Joint Validation & Verification Report For Carbonsafe Carbon Farming Project – South Bulgaria

KEY PROJECT INFORMATION	
Report ID	CSP.JVV.25.012 (1)
Project Title	Carbonsafe Carbon Farming Project – South Bulgaria
Project ID	CSBG-BG-S
Sectoral Scope	UNFCCC 15 – Agriculture Technical Area 15.1
Project Start Date	17 January 2023
Crediting period	2023 - 2063
Monitoring Period	23 March 2024 to 15 May 2025
Date of issue	05 August 2026
Version of this document	v1.1
Methodology applied	Methodology for Improving and Reporting the Level of Sequestered Carbon in the Soil in the Agricultural Sector, Version 3.1/22.08.25
Standard	Balkan Carbon Credit Standard (BCCS)
Net amount of GHG removed (t CO ₂ eq)	423,411
Gross amount of removed GHG emissions (t CO ₂)	537,445
Net SOC Change (t C)	146,555

Figure 1(a): The box encircled in yellow, showcases the supposed vectorized data

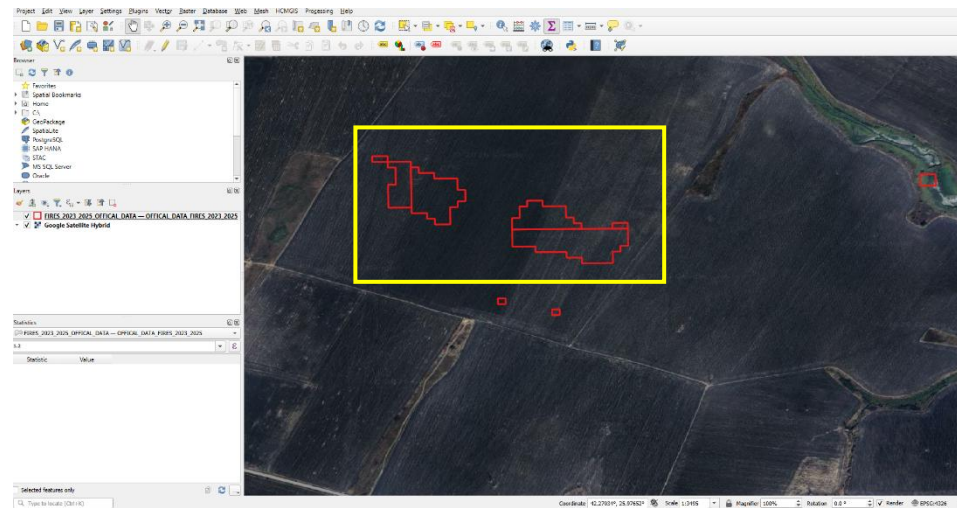
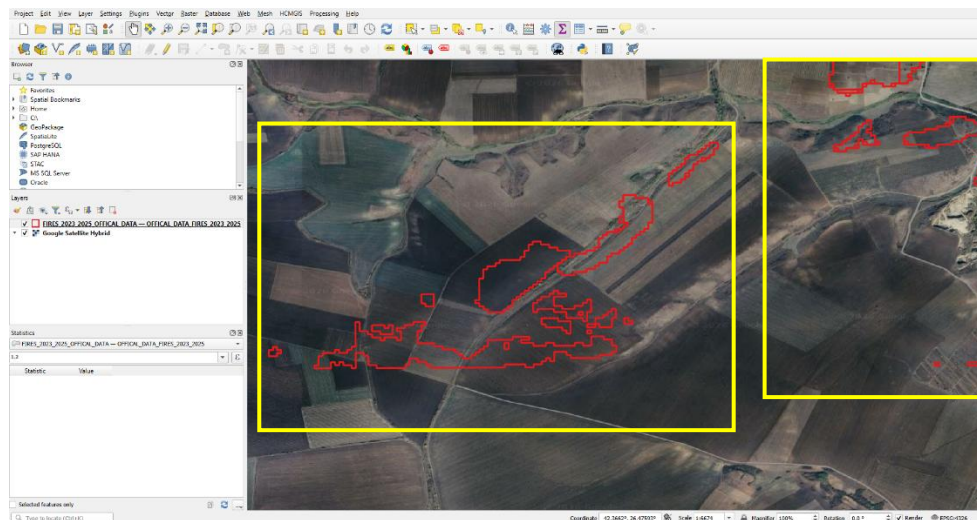
(a) The PP has provided the VVB with the “**FIRES_2023-2025**” geojson file and found that some of the delineated/demarcated polygons appear to be vectorized. Sample screenshots of the same are as indicated below:

NOTE: The PP is requested to note that the above are only sample screenshots where vectorization of some of the delineated polygons was visible. The PP must provide complete clarity over the same and ensure that the delineated polygons across this entire geojson file are corrected, and

demarcated/delineated properly. These corrections must be implemented across all the 20 Zip Folders provided as evidence to the VVB.

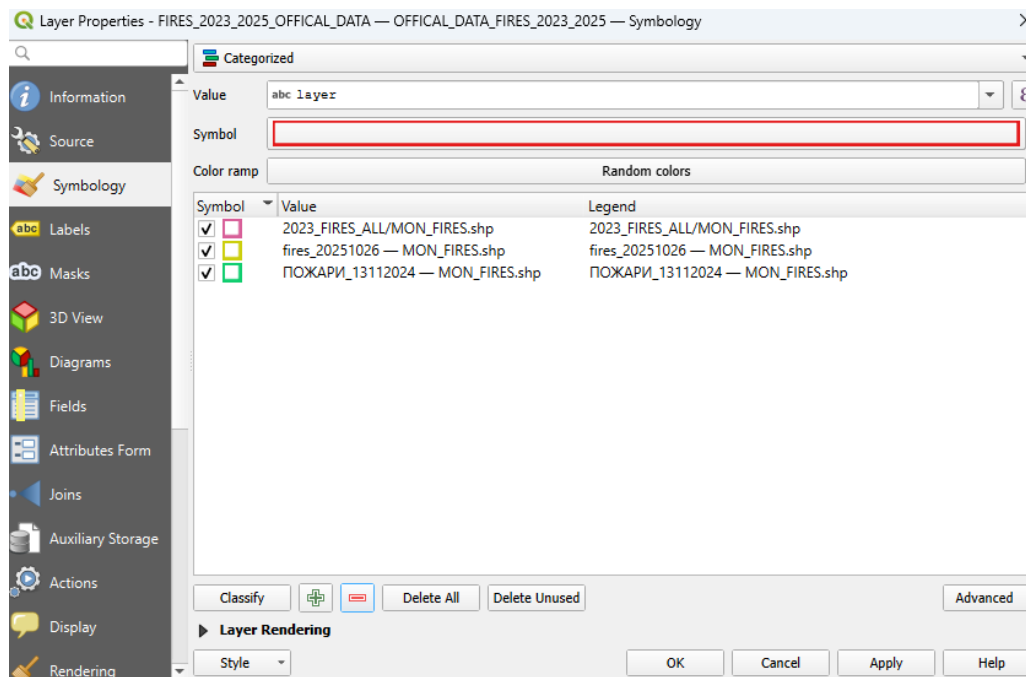
(b) Additionally, no geospatial Raster (TIFF/GeoTIFF) Classified Fire Maps have been provided by the PP to the VVB. The PP is required to provide these raster fire maps to the VVB for assessment as well. The PP must also provide the exact Dates of Acquisition of these images.

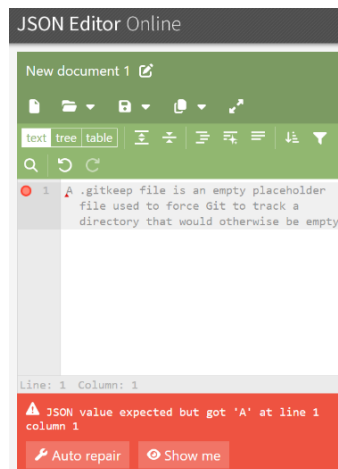
(vi) The PP has also provided “**AGRARIKA_2022_BELT_COPPER**” and “**AGRARIKA_2022_CP_ALL**” geojson files to the VVB. The PP must explain as to what these geojson files really and truly indicate and represent.

Figure 1

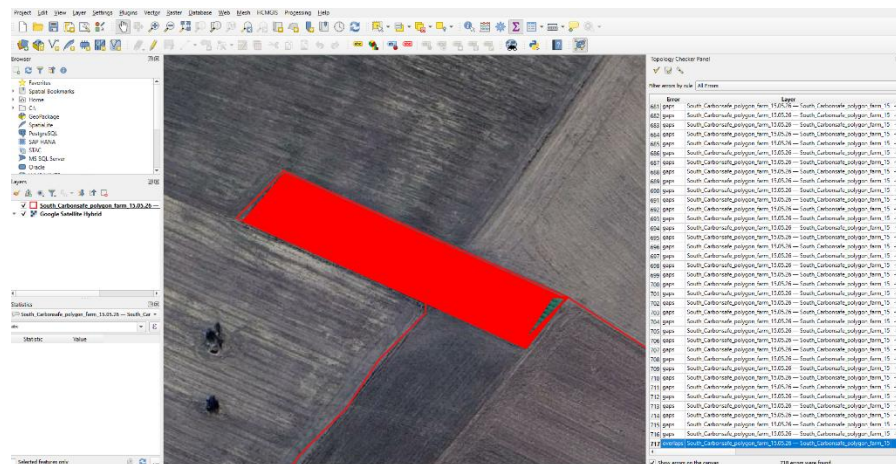
(ii)The “South_Carbonsafe_polygon_farm” GeoJSON file showcase Topological Errors like Overlaps and gaps. Screenshots of the same have been attached below. A total of 718 Topological Errors were identified. Screenshots of the same have been indicated below:

Case 1: Overlaps

Figure 2(a)

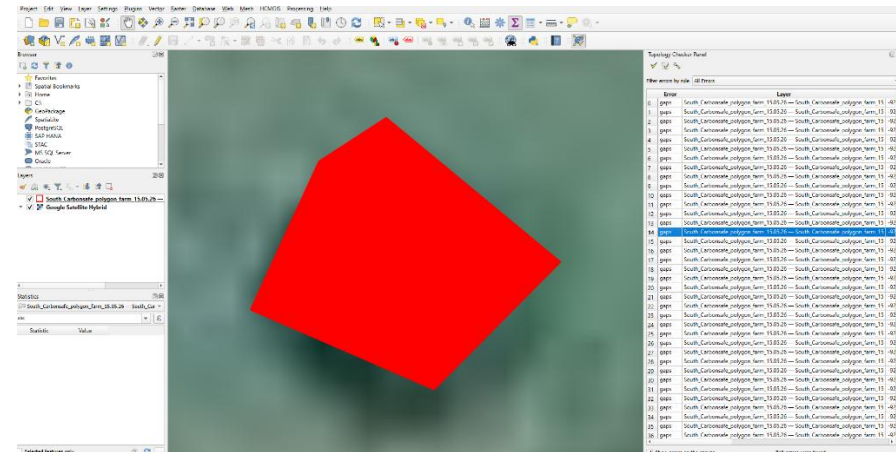
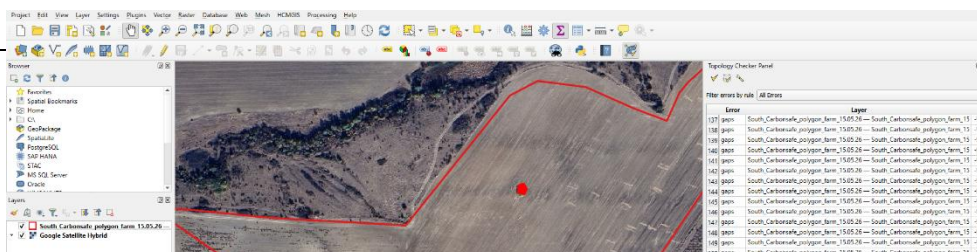
Case 2: Gaps

NOTE: The above are only Sample Screenshot Representations of the areas where Topological Errors were observed. The PP must ensure that all the 718 Topological Errors identified must be removed from the "South_Carbonsafe_polygon_farm" GeoJSON file. Apart from this, the PP must change the spelling from Deference to Difference.

Figure 1(a): The box encircled in yellow, showcases the supposed vectorized data

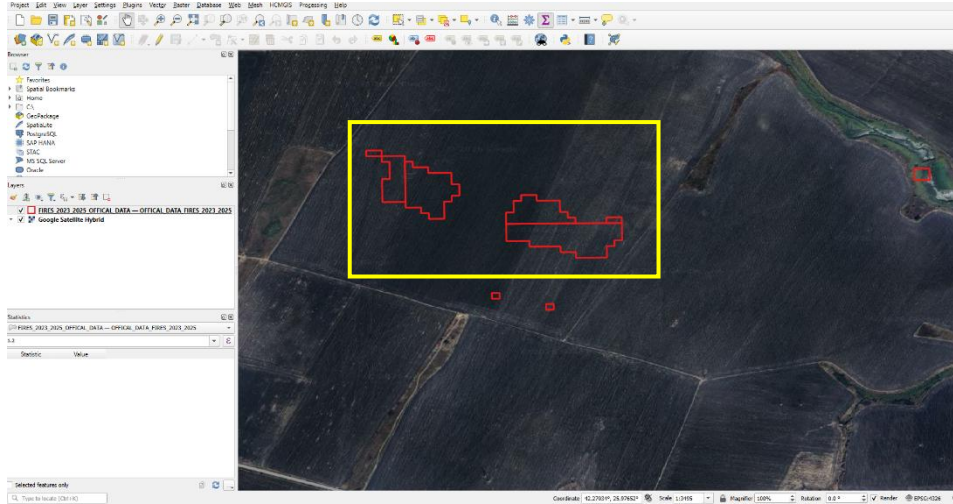
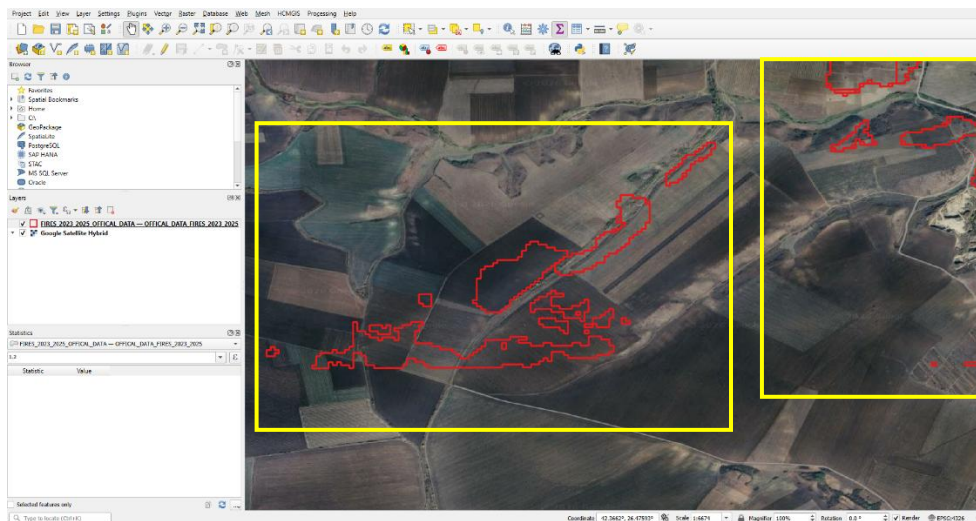
(a)The PP has provided the VVB with the “FIRES_2023-2025” geojson file and found that some of the delineated/demarcated polygons appear to be vectorized. Sample screenshots of the same are as indicated below:

NOTE: The PP is requested to note that the above are only sample screenshots where vectorization of some of the delineated polygons was visible. The PP must provide complete clarity over the same and ensure that the delineated polygons across this entire geojson file are corrected, and demarcated/delineated properly. These corrections must be implemented across all the 20 Zip Folders provided as evidence to the VVB.

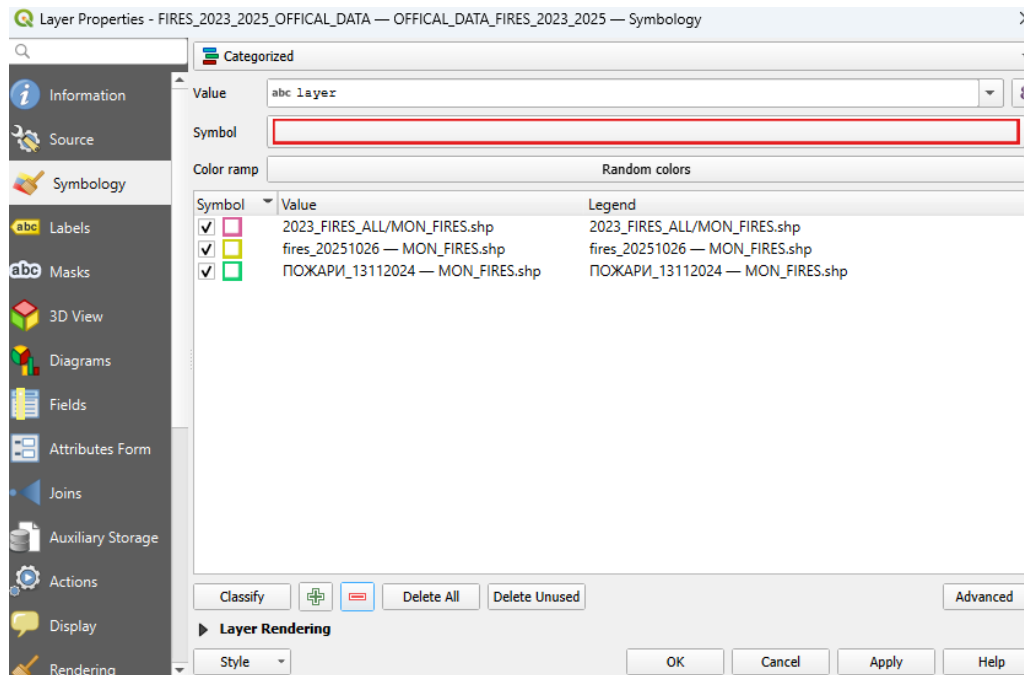
(b)Additionally, no geospatial Raster (TIFF/GeoTIFF) Classified Fire Maps have been provided by the PP to the VVB. The PP is required to provide these raster fire maps to the VVB for assessment as well. The PP must also provide the exact Dates of Acquisition of these images.

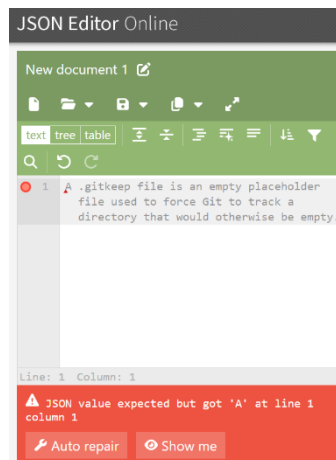
(vi)The PP has also provided “AGRARIKA_2022_BELT_COPPER” and “AGRARIKA_2022_CP_ALL” geojson files to the VVB. The PP must explain as to what these geojson files really and truly indicate and represent.

Figure 3

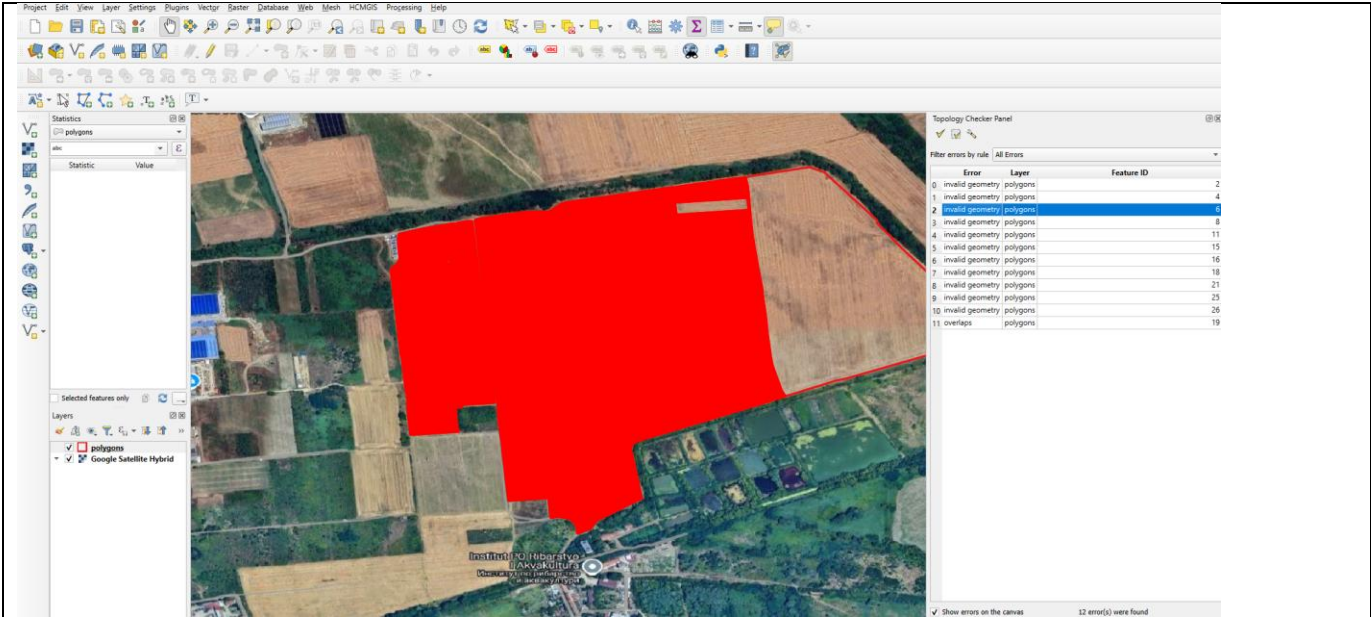
(i) *Overlaps*

(ii) *Invalid Geometry*

NOTE: The above are only sample screenshots of the areas where Topological Errors were found to occur. The PP is requested to correct all the Topological Errors found to occur across all the Farm Name Shapefiles.

Project participant response	Date: 12/05/2026
Topological Errors are corrected.	
Documentation provided by project participant	
Updated GIS Data (GeoJSON, CSV and EXCEL Reference) are provided in folder VER-CL 02.2	
VVB assessment	Date: 27/05/2026

Figure 1

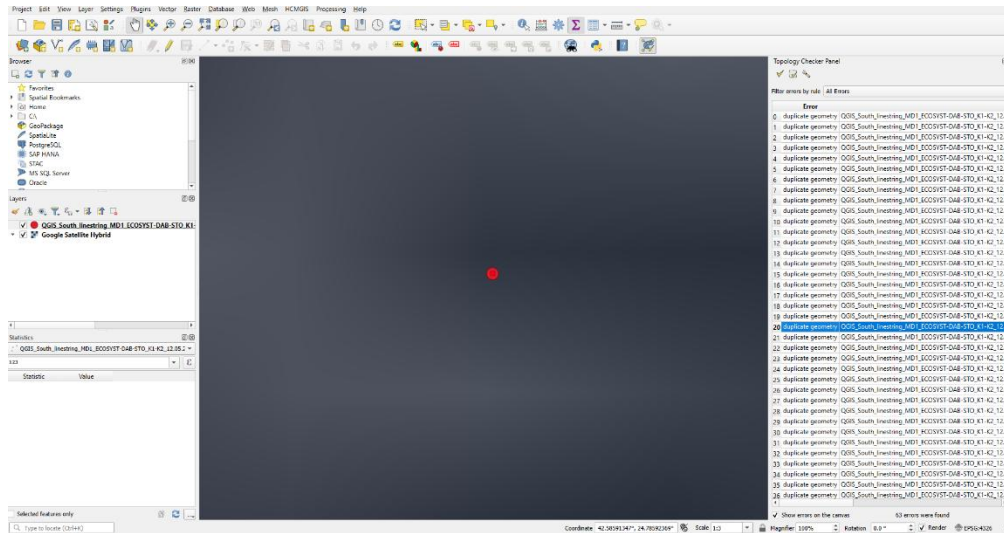
(i)When the VVB inspected the linestring “ECOSYST-DAB” GeoJSON file, the VVB found a “Duplicate Geometry” Topological Error. A screenshot of the same has been showcased below:

Figure 1: Presence of Roads

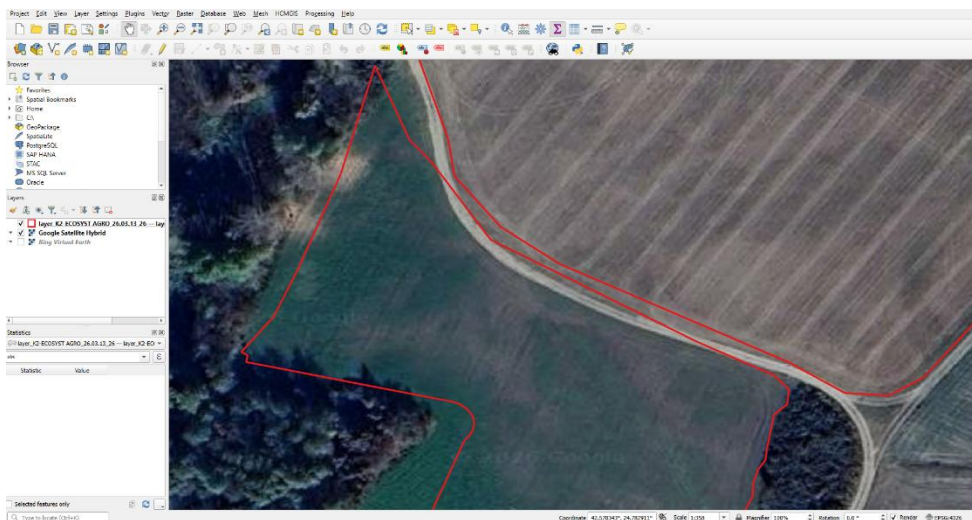
(iv)Additionally, the VVB observed the prevalence of Non-Eligible Areas in the provided and updated GeoJSON Files. Sample screenshots of the same have been showcased below:

Case 1: layer_K2-ECOSYST GeoJSON File

Figure 3: Water Seepage/Runoff visible in the delineated polygon above

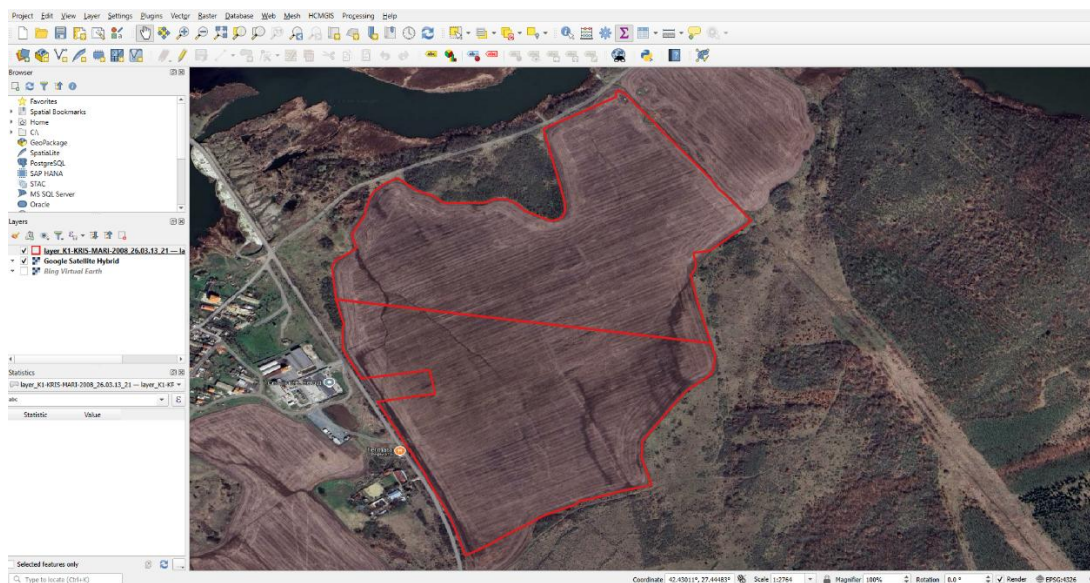
Case 2: layer_K1-KRIS MARI-2008

NOTE: (i) The PP needs to note that the above screenshots are sample screenshots of representation of where Topological Errors were observed for some of the Farms. The PP must remove these “Gaps” Topological Errors and incorporate the Geographic Coordinates (Latitude, Longitude) values across all the provided GeoJSON files.

Regarding the identified areas with potential water seepage/runoff (Figure 3), we would like to provide the following detailed explanation of the factors determining the visual characteristics of the terrain:

Figure 1: Improper Delineation as some rocky patches is also encompassed

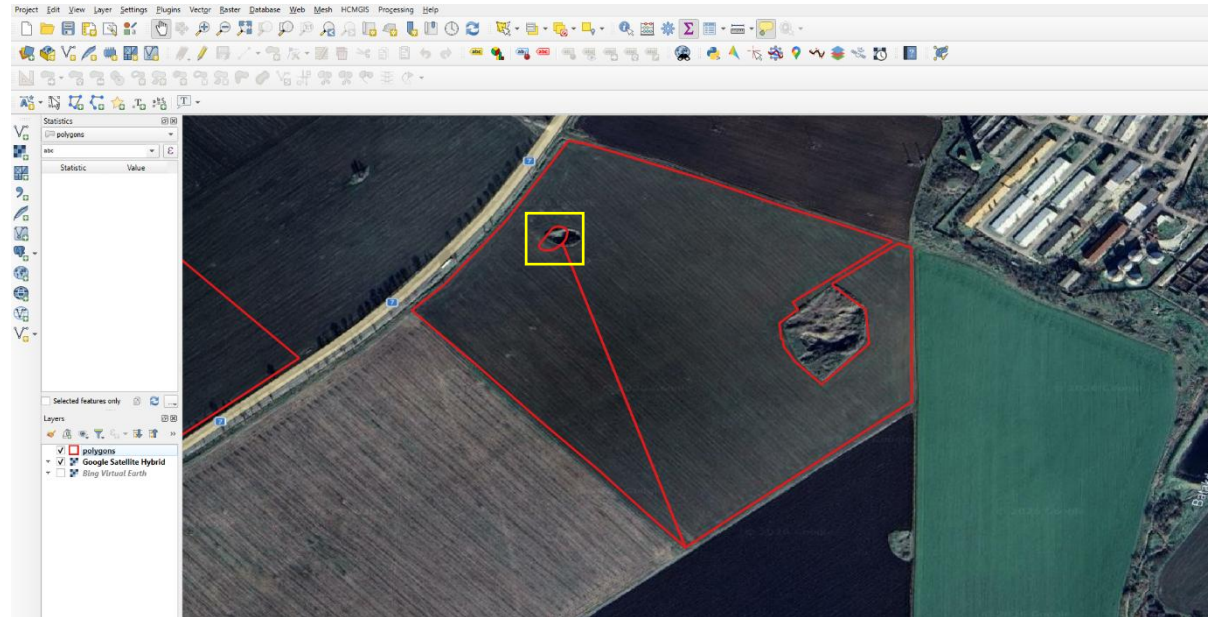
(i) The following Non-Eligible Areas were found to occur, the sample screenshots of the same have been attached below:

Case 1: AGROTREYD EOOD_S

Figure 2: Presence of Dirt Roads

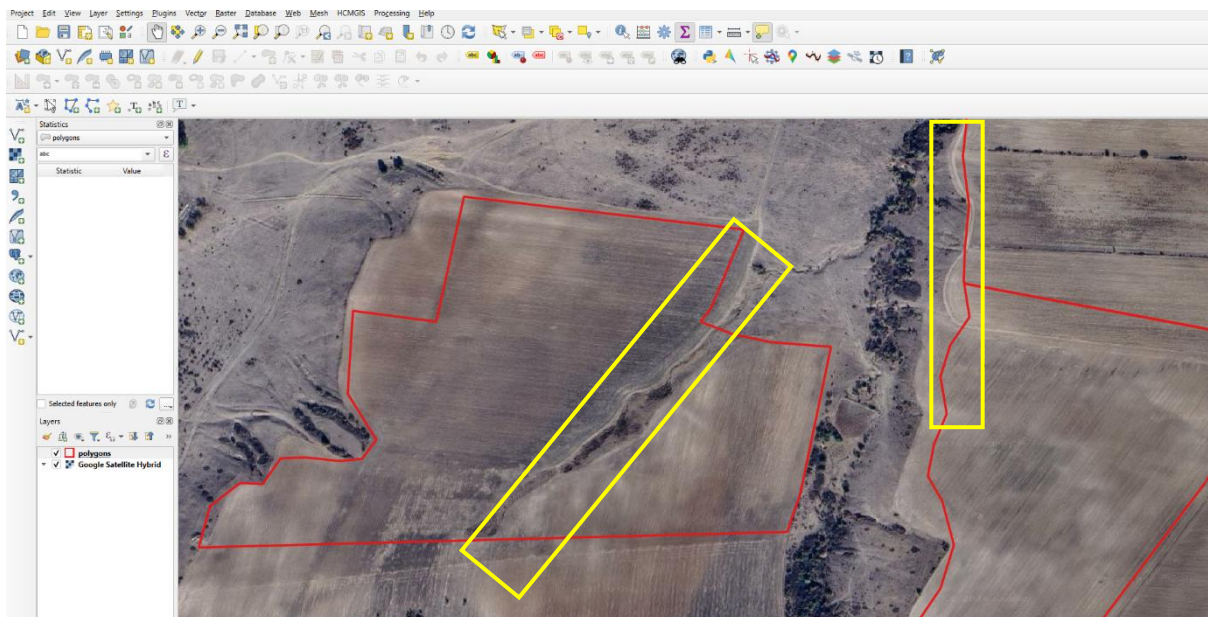
Case 2: KURTEV GRUP OOD_BG 21_S
